**Operable Unit B1
Interim Record of Decision
(ROD)**

for McCLELLAN AFB, CALIFORNIA

FINAL

JULY 1993

Figure 6-2. Inorganic Cleanup Standard Determination for OU B1 Surface Soils and Sediments

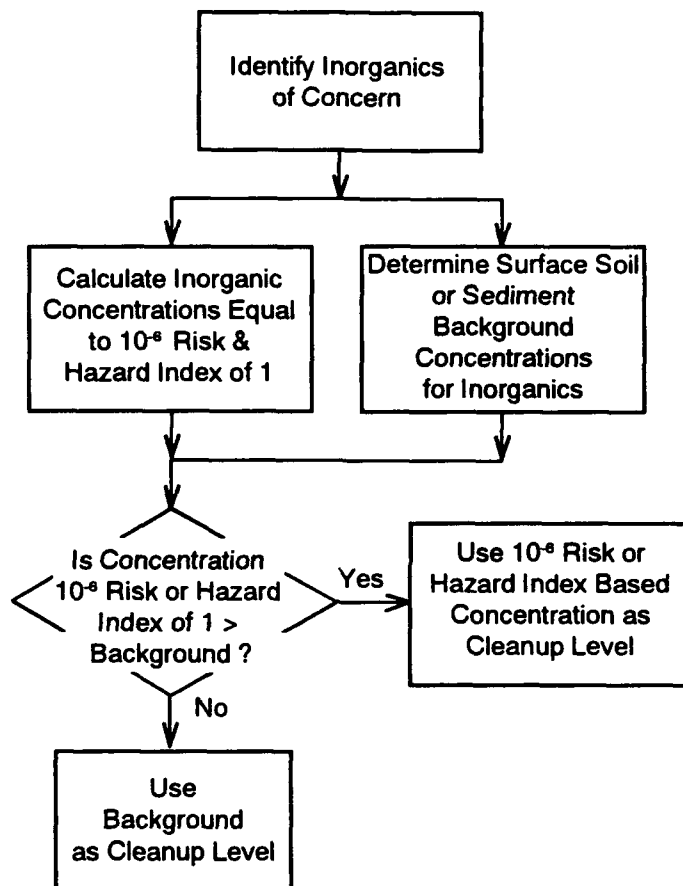
COMMENT SUMMARY: *Clarify last sentence that supports Figure 6-2. Use an inorganic cleanup level that is the more conservative of 10^{-6} risk, a hazard index (HI) of less than one, or five times background.*

Specific Comment 13, Page II-40, Figure 6-2

Figure 6-3. Conceptual Design of the Capping Alternative

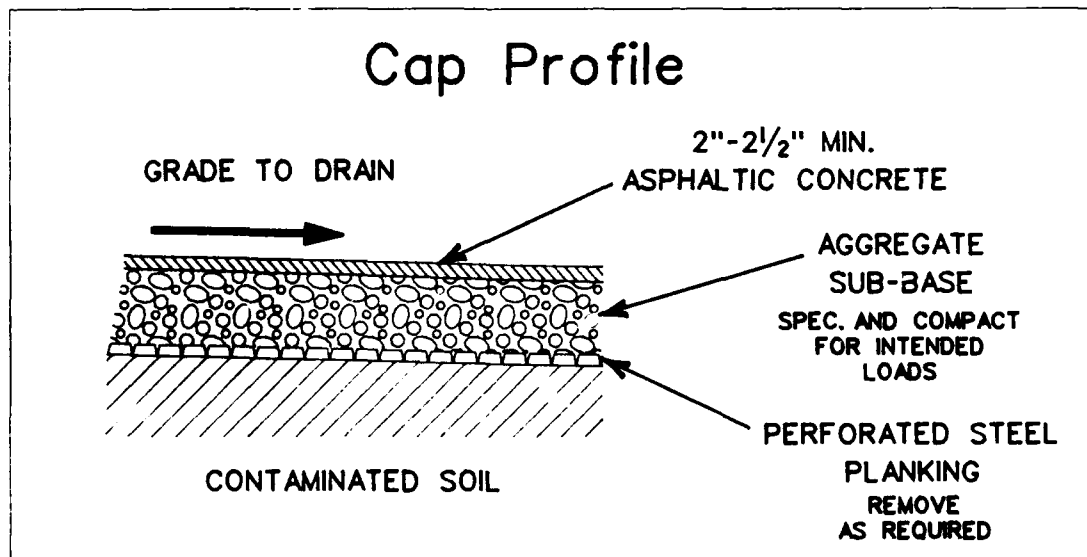
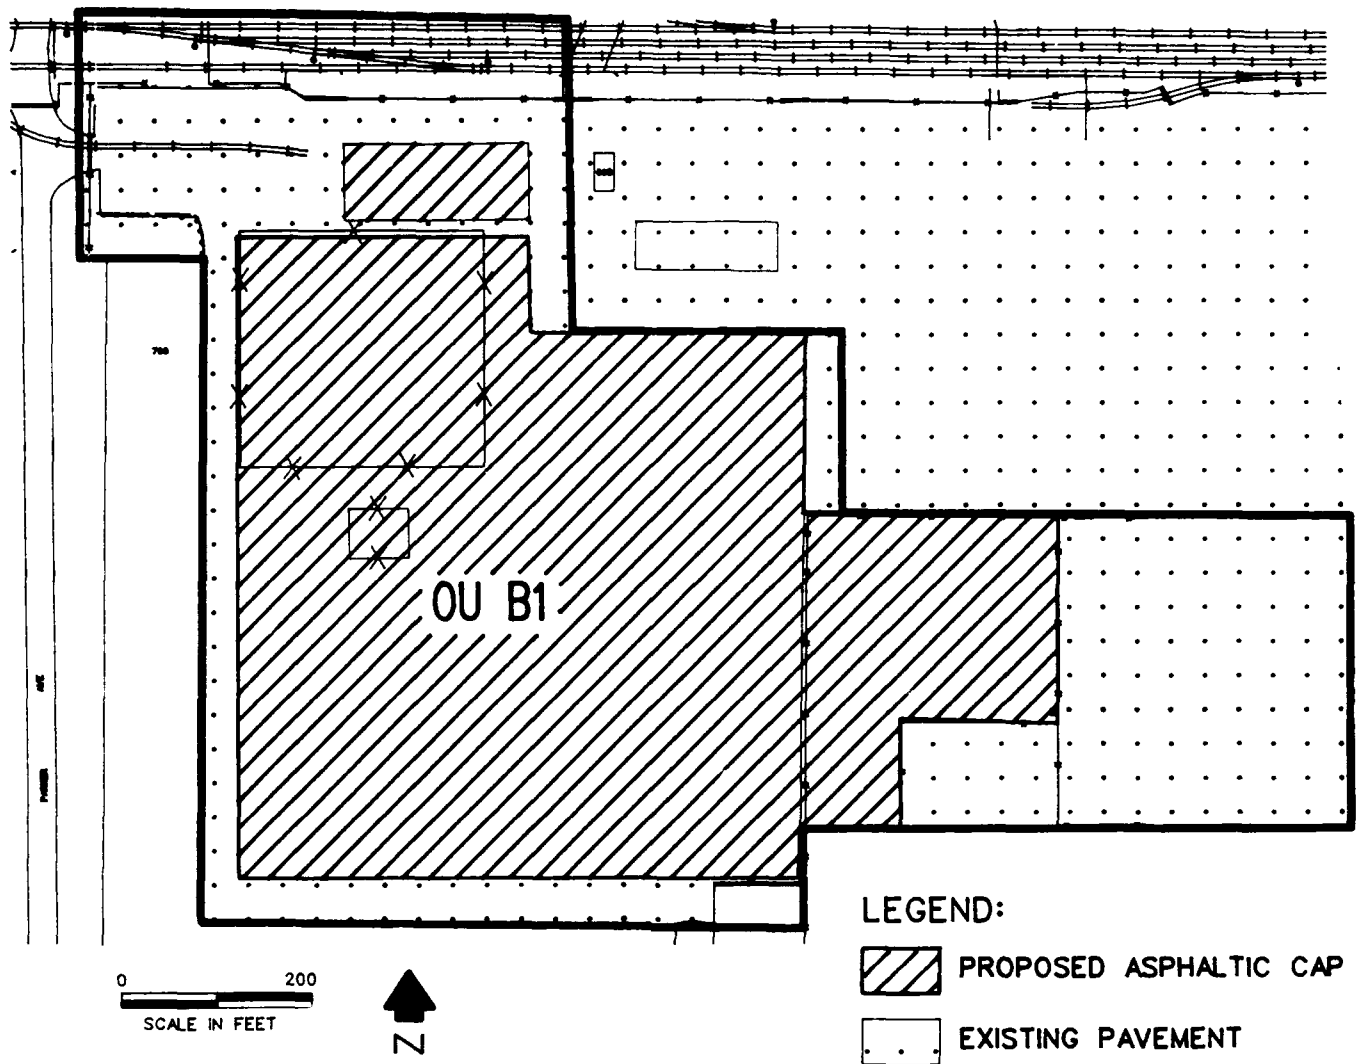
COMMENT SUMMARY: The 2" minimum asphaltic cap shown in Figure 6-3 differs in width from the 2.5" cap used for costing purposes.

Figure 6-3 has been revised to show a 2-2½" minimum cap thickness. The actual thickness of the cap will be specified during the cap design, based on thickness required to handle equipment loads. The 2½" thickness used in the costing is a reasonable estimate of the design.

Figure 8-1. Decision Logic Diagram for Remediation of All Media in OU B1

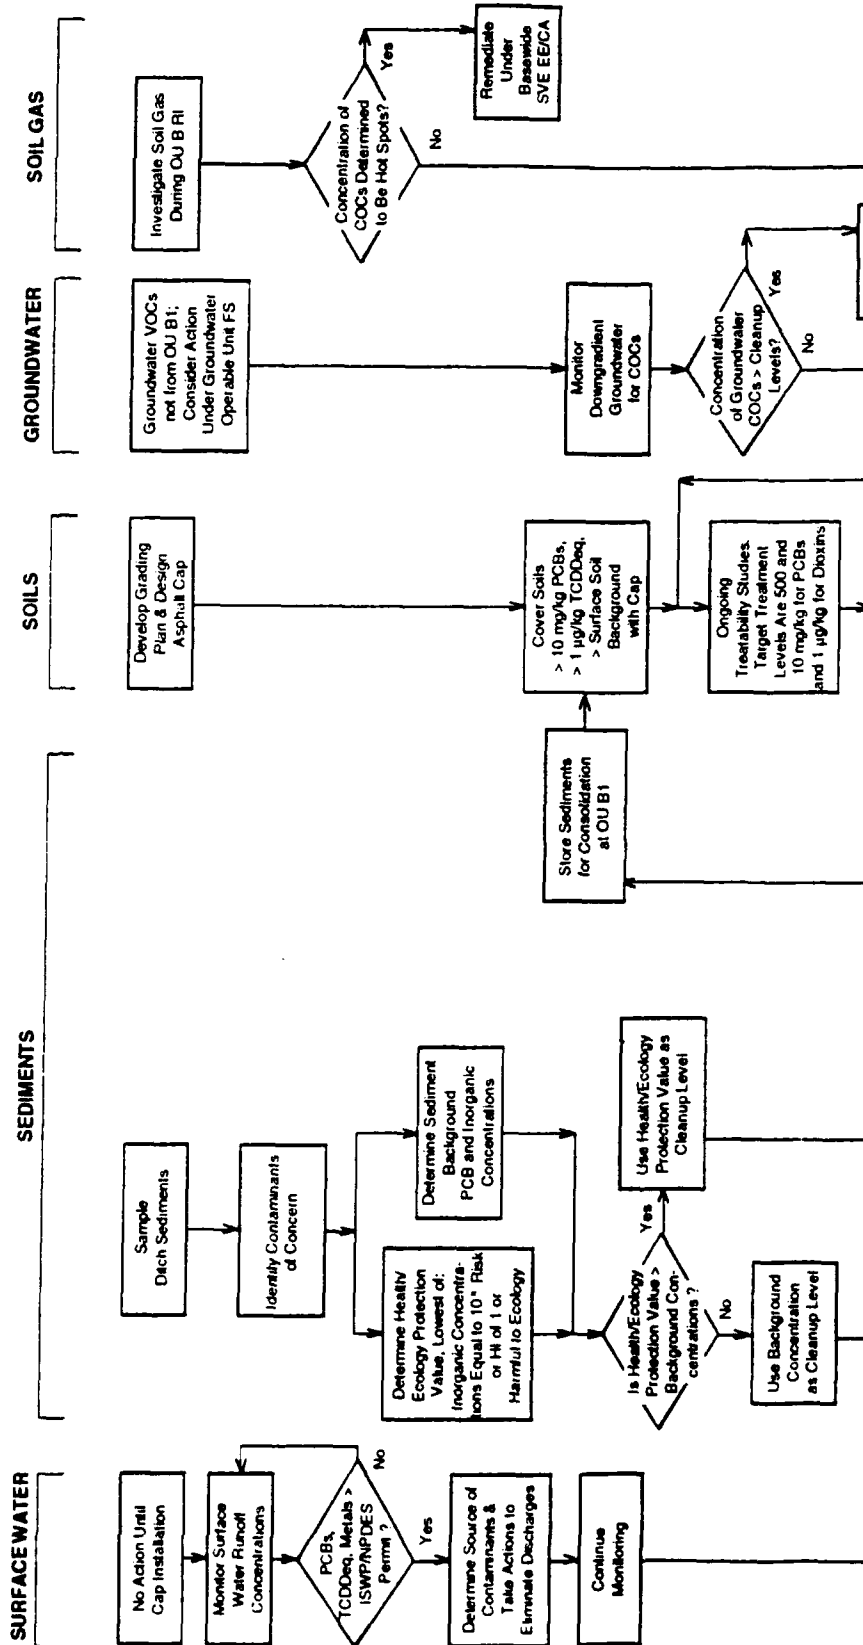
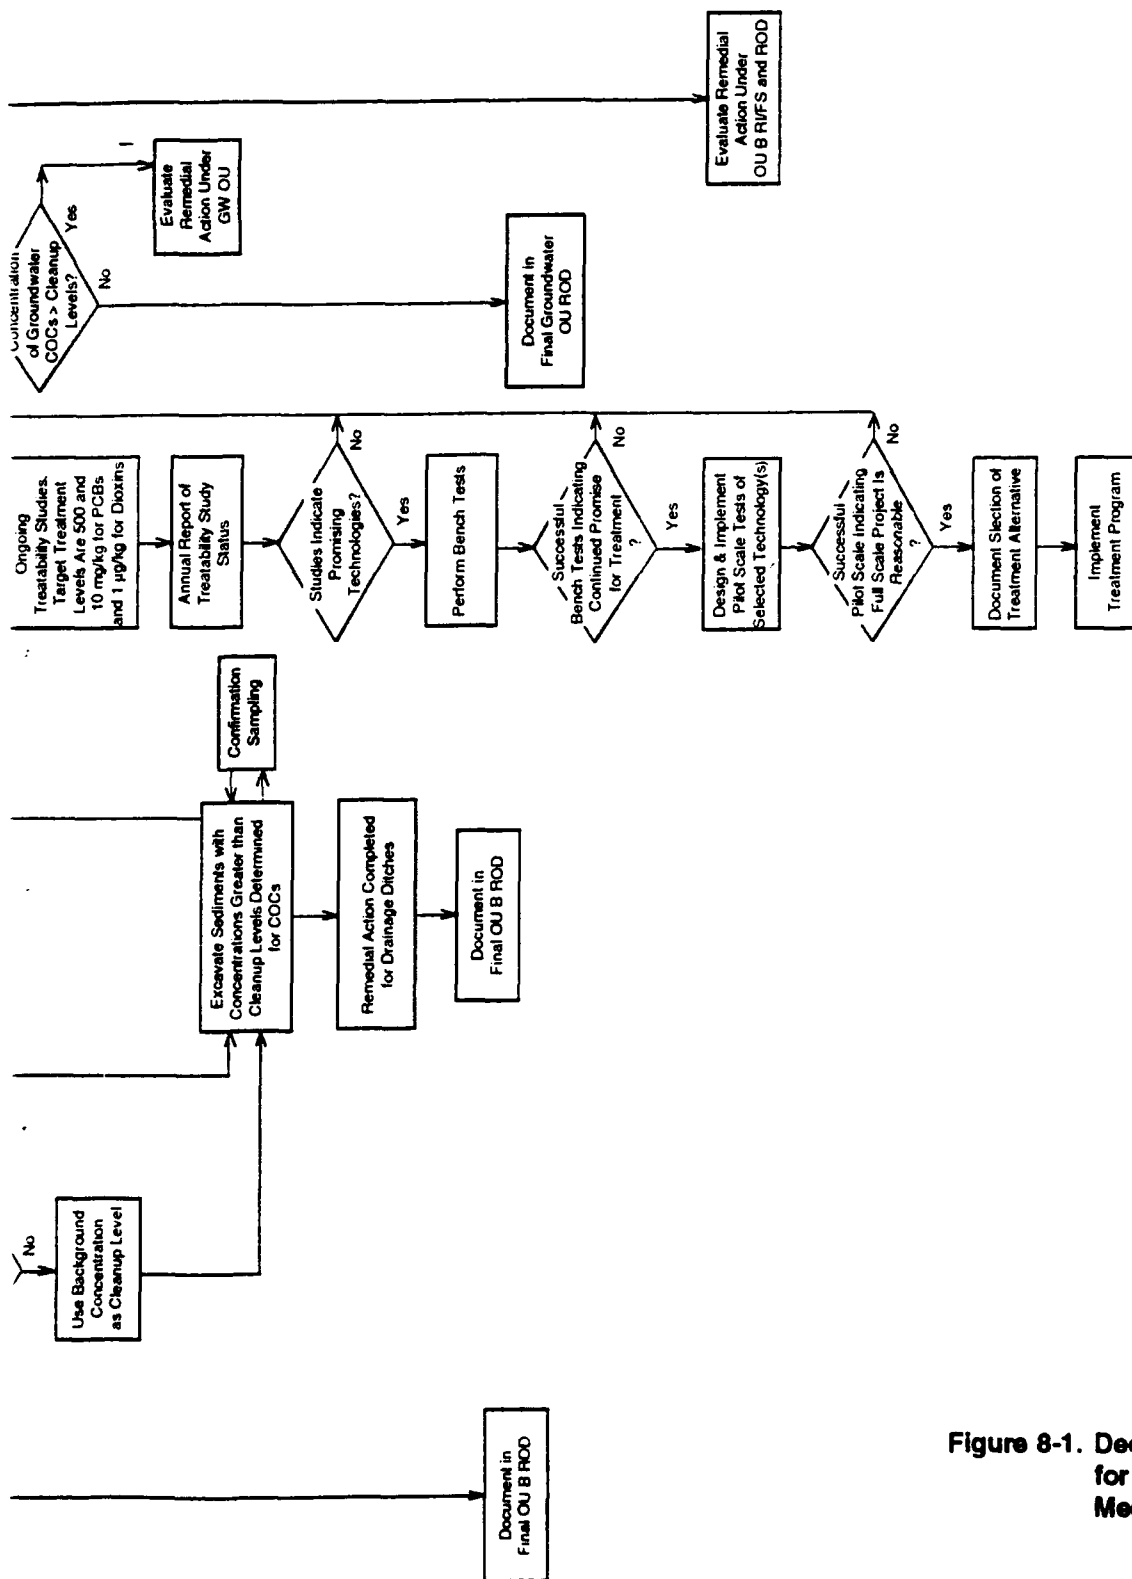
Comment 20, Figure 8-1

Specific Comment 17, Page II-60, Figure 8.1
